Application for Licence Amendment

Licence Number	L9056/2017/1
Licence Holder	Pilgangoora Operations Pty Ltd
ACN	616 560 395
File Number	DER2017/000318
Premises	Pilgangoora Lithium – Tantalum Project Mining Tenements M45/1256 and L45/417 MARBLE BAR WA 6760
Date of Report	7 April 2022
Decision	Revised licence granted

Figure 1: Landfill location

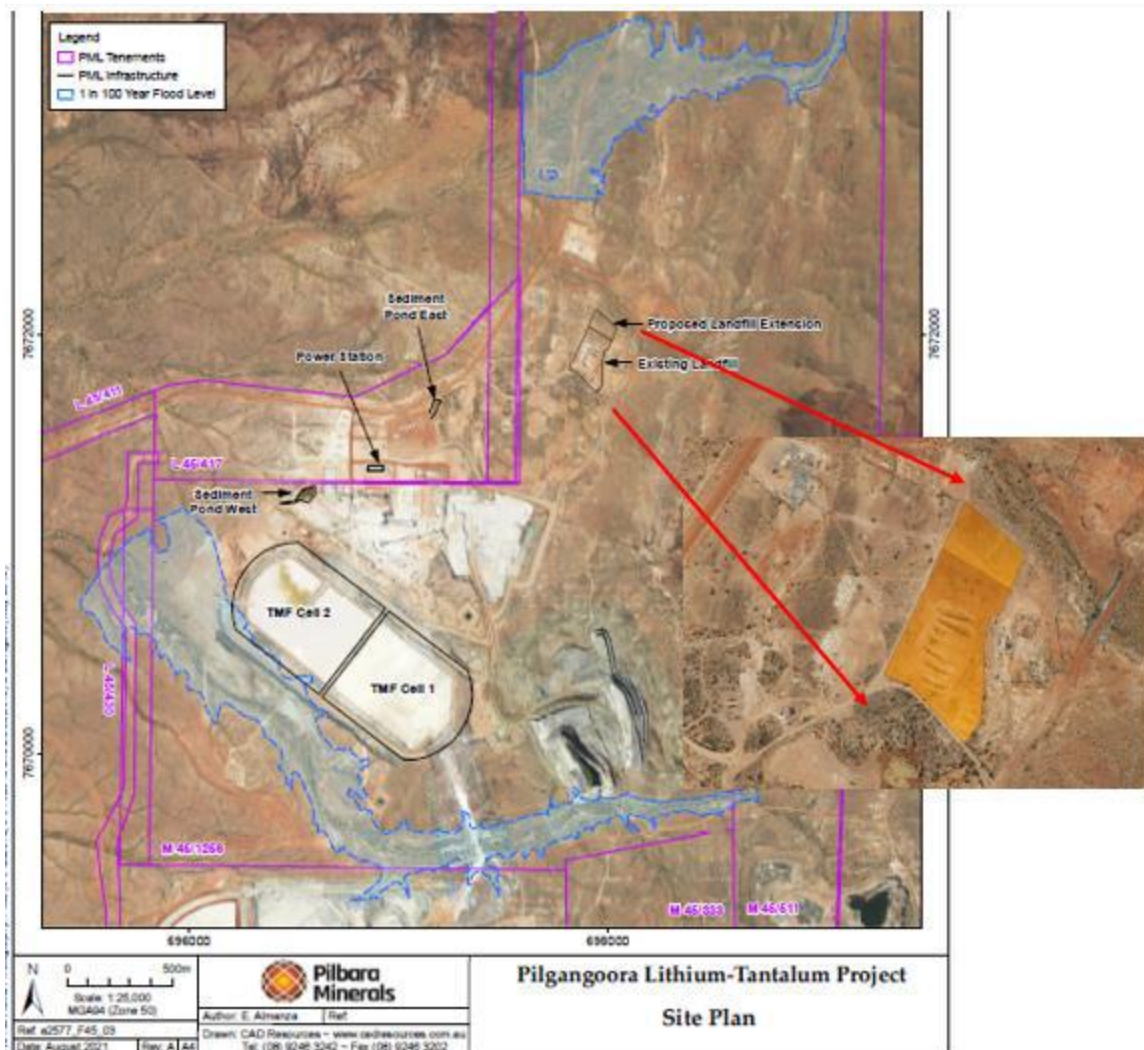
- increase the design capacity for Category 54 from 5,000 tonnes/year to 10,000 tonnes/year; and
- increase the footprint of the existing landfill on the premises by one hectare as per Figure 1 below.

The Licence Holder has proposed a maximum of 10,000 tonnes of putrescible, inert waste types 1 and 2 and contaminated solid wastes to be disposed of into the west waste dump per annum. Putrescible, inert and contaminated solid waste is to be placed in separate trenches within the landfill. More trenches will be implemented as required.

The Licence Holder has proposed to maintain the existing operational controls on the landfill as per Licence L9056/2017/1. Figure 1 below shows the proposed location of the landfill extension, which remains outside flood levels of a 1 in 100-year rain event.

Figure 2: Estimated drainage from tailings thickener into sediment pond

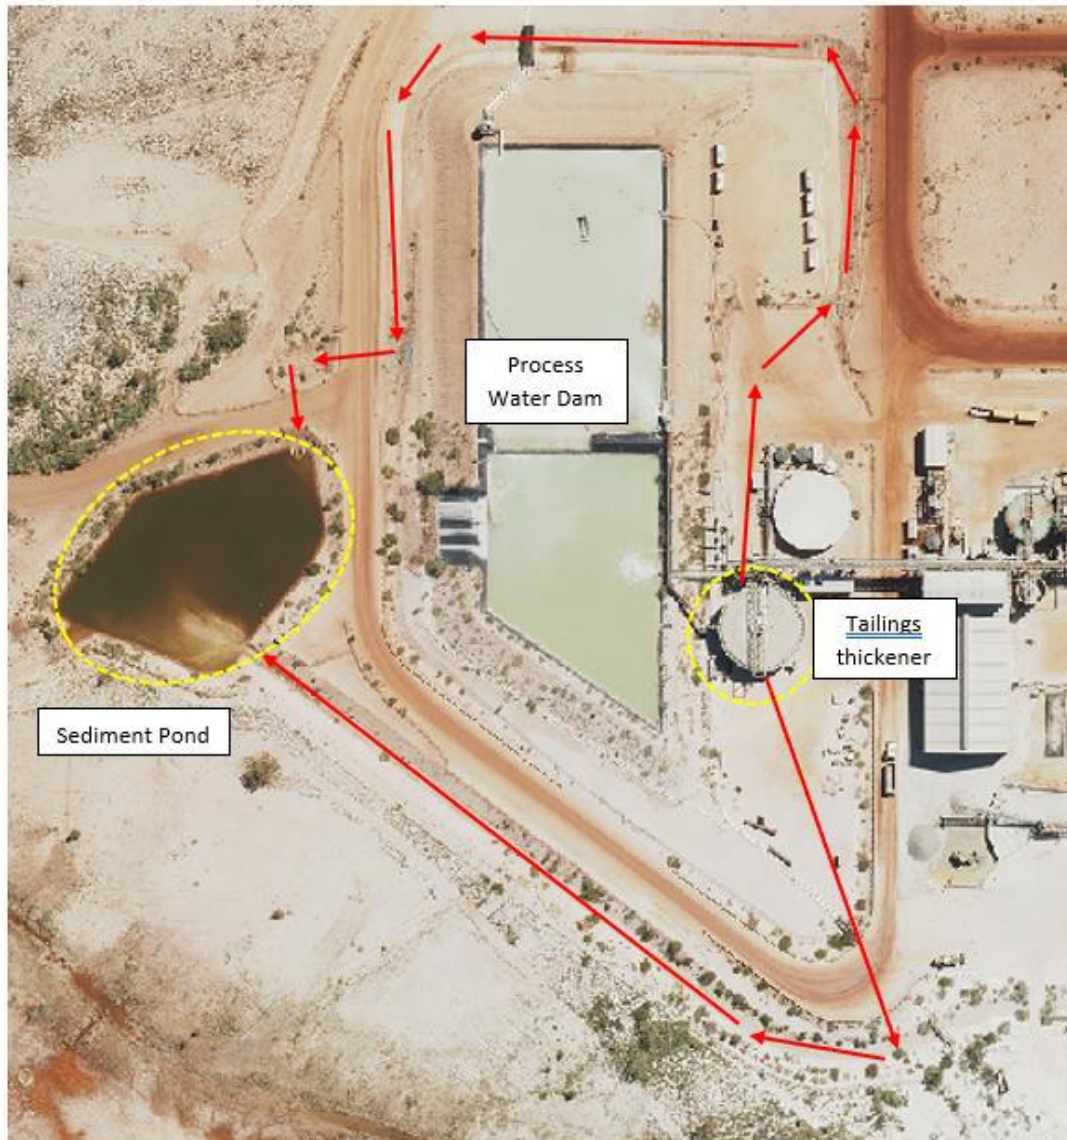
The Licence Holder has requested that tailings thickener of the Pilgan Plant be exempt from the requirements of having a concrete bund with 110% capacity of the tank, and drainage to the process water pond.

The Licence Holder states that given the location of the thickener and the existing drainage lines in the area, any spill from the thickener would drain into the sediment pond (west) as shown in Figure 2 below.

The Licence Holder proposes to use existing drainage lines to direct any major spills or leaks from the tailings thickener to the sediment pond downslope, 130 m to the west. This will act as containment facility in the event of a spill or overflow event. The Licence Holder has conducted a survey of the sediment pond and has confirmed that its containment capacity is 4,145 kL, which is more than the current 1,901 kL capacity of the tailings thickener.

In considering the likelihood of a significant failure or discharge from the tailings thickener, and the capacity of the sediment pond during normal operations to act as containment facility, the Delegated Officer considers the likelihood of this risk event to be unlikely. The Delegated Officer therefore considers that the proposed controls to manage the risk of significant failure or discharge from the tailings thickener are sufficient and has amended the infrastructure requirements on the licence for the tailings thickener.

<p>water pond.</p> <p>The alternative controls in place, that would detect spills/leaks, include:</p> <ul style="list-style-type: none"> - tailings thickener has bed level alarm linked to the control system, which indicate if there was a leak in the tailings thickener; - constant monitoring via digital CCTV cameras; and - visual inspection of the area at least twice a day (once per shift). 	<p>Licence Holder are acceptable. These controls have been added to the revised Licence.</p>
--	---	--

Figure 3: Monitoring bore locations

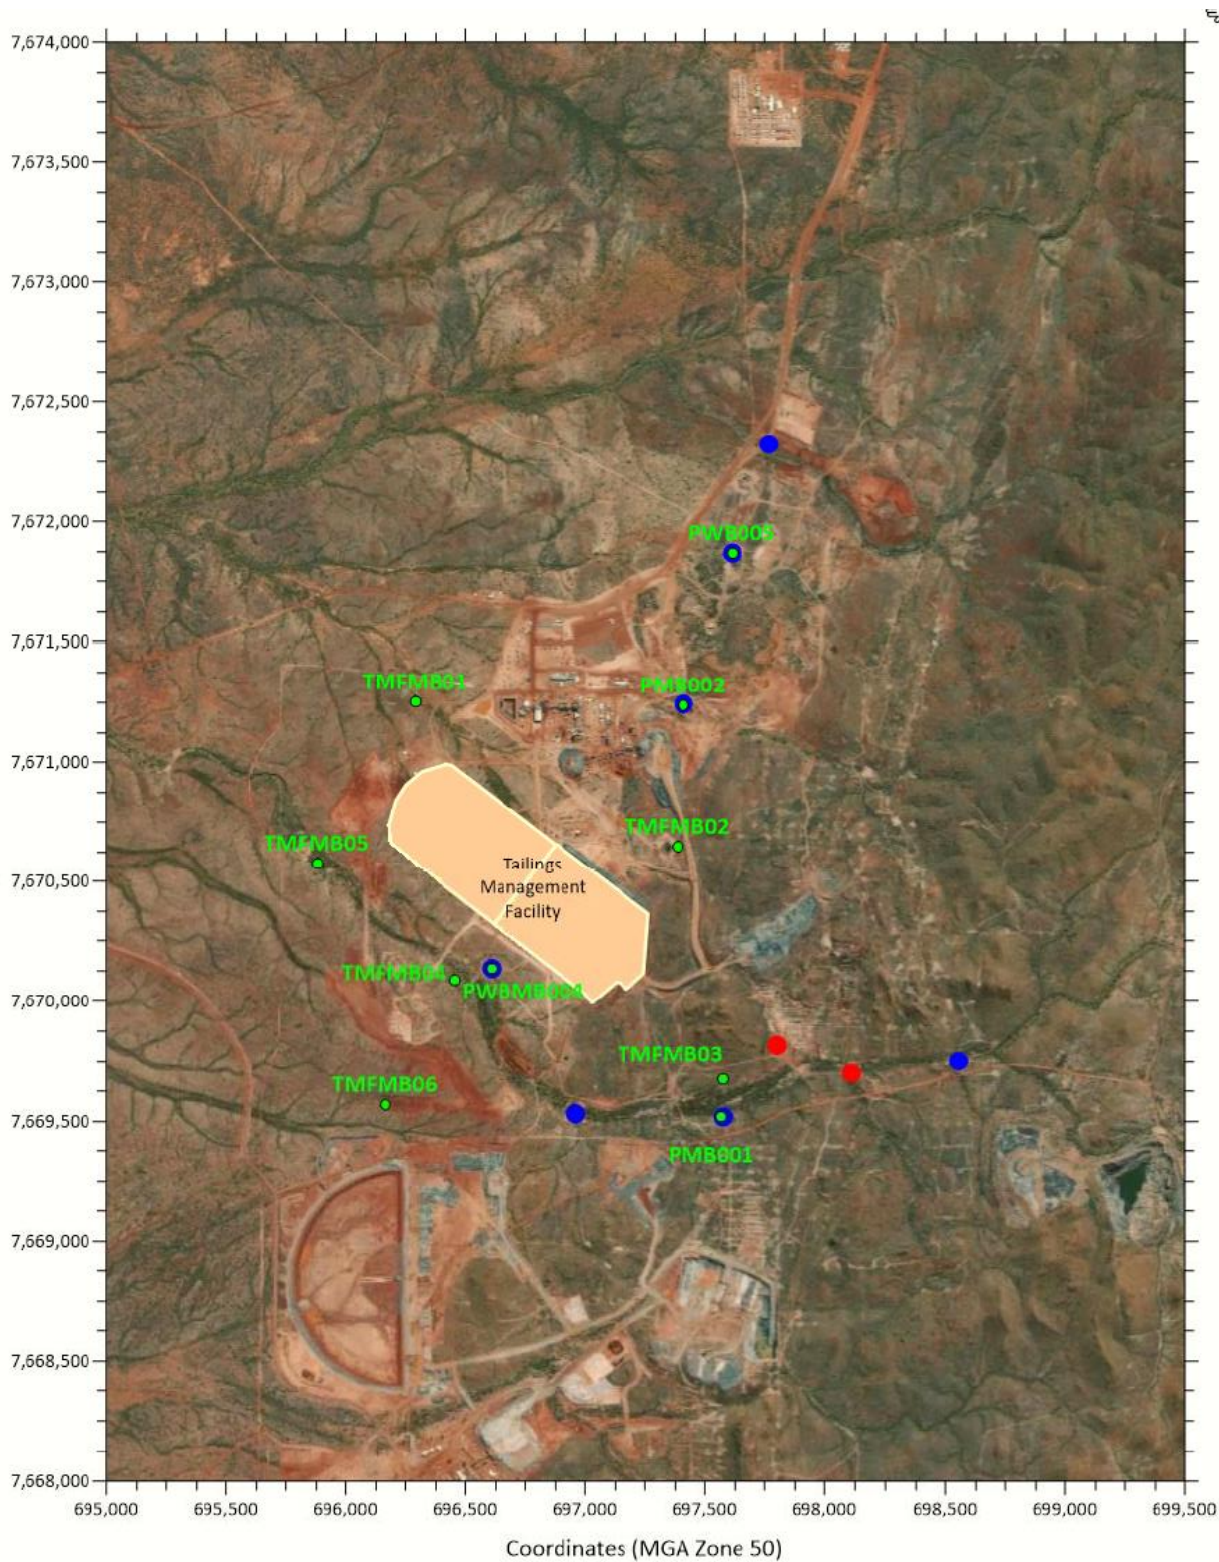
The GRM study detailed that groundwater level data from six of the ten installed groundwater monitoring bores surrounding the Pilgan TMF have exceeded one or both Standing Water Level (SWL) trigger and limit levels imposed by Licence L9056/2017/1. The monitoring bores which exceeded the SWL trigger level are PWB005, PWBMB004, TMFMB01, TMFMB02, TMFMB04 and TMFMB05.

- Production bore PWB005 has formed one of the primary water supply bores for the duration of the project (GRM, 2021). SWL monitoring data from PWB005 has tended to be uniform throughout the reporting period with only one exceedance in the SWL nominated trigger level for a brief period in June 2020. Given that the bore is located approximately 1.5 km north of the TMF, the GRM report indicates this is more likely that this rise is due to seasonal fluctuation, than to seepage from the TMF.

- Monitoring bore TMFMB04 is located approximately 300 m to the south of the TMF, within 150 m from water supply bore PWB004. The bore is located on the southern bank of the Pilgangoora Creek, which is the opposite side of the creek to the TMF and PWB004 and is up-hydraulic gradient from the TMF. The groundwater level trend is very similar to that of TMFMB01 and TMFMB02. However, there are no clear trends in the groundwater quality data. The bore exceeded the SWL trigger value in November 2019 and has continued to exceed either the trigger value or limit value since this time. The location of the bore (i.e. up-hydraulic gradient) of the TMF, and groundwater quality data suggest that the rising groundwater level in this bore may be the result of

- Monitoring bore TMFMB05 is located approximately 300 m to the southwest of the TMF, adjacent to the Pilgangoora Creek and at least 900 m from the nearest water supply bore (PWB004). The bore is not likely to be impacted by groundwater abstraction. The groundwater level data demonstrates a typical seasonal variation, with groundwater levels rising following high rainfall events and falling during the dry winter periods. The water quality data does not show any obvious trends in lithium, TDS or pH. However, the bore has reported exceedances of both the trigger and limit values since May 2020. The data suggests that the rising groundwater levels reported in this bore are likely to be due to natural seasonal variation.

As a result, the Licence Holder propose to amend Condition 12, Table 8 of L9056/2017, and change the SWL trigger (7 mbgl) and limit (5 mbgl) of PWB005, TMFMB04 and TMFMB05, to 5 mbgl and 3 mbgl respectively.

The Delegated Officer notes the above detail in section 2.2.4. While seepage management from the TMF is currently under investigation by department, the Delegated Officer considers that there is enough evidence to support the Licence Holder's assessment of seasonal SWL

variation in the respective monitoring bores. The proposed changes to SWL trigger and limit of PWB005, TMFMB04 and TMFMB05 have been included in the revised Licence. It is noted that issues regarding seepage management from the TSF are likely to be considered in future TSF embankment raises.
